Product Alert

Reliable Automatic Sprinkler Company, 8 in. NPS Model DDX and EX Sprinkler System Control Valves – Safety Concern

8” (200 mm) Model DDX Dry/Deluge/Preaction & Model EX Dry Valves

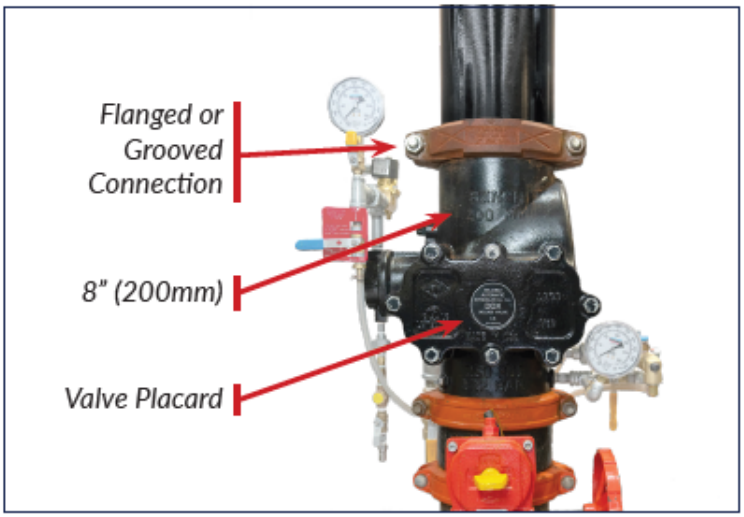
From 2008 until present Reliable® has manufactured 8" (200 mm) Model DDX, Dry, Deluge, and Preaction Valves and Model EX Dry Valves. These dry, deluge, and preaction valves are hydraulically operated, latching clapper-type valves used to control the water supply to deluge, preaction or low-pressure dry pipe systems. The circular valve placards read:

- DDX-LP or EX Low Pressure Dry Pipe Valve
- DDX Deluge Valve (pictured)
- DDX Single Interlock
- DDX Double Interlock Type D
- DDX Double Interlock Type F
- DDX Type PL Double Interlock
- DDX Non Interlock

The 8" (200 mm) version of the valve incorporates a striker plate to avoid stress on the valve clapper. The striker plate and clapper are held closed prior to operation of the valve by a latch. Reliable has recently become aware of rare circumstances where the striker plate and clapper do not properly release from the latch upon activation.

In order to ensure performance, Reliable is announcing a field upgrade program to be performed by a licensed local contractor as soon as practical. Reliable will provide the contractors with replacement instructions and the necessary upgrade components and tool for the valves.

It should be noted that the 2" (50 mm), 2-½" (65 mm), 3" (80 mm), 76 mm, 4" (100 mm), 6" (150 mm) Models DDX and EX do NOT require this field upgrade. Only the 8" (200 mm) versions produced prior to June 2025 are affected. PrePaK™ cabinet-enclosed valve systems using an 8" (200 mm) Model DDX or EX valve are also affected.
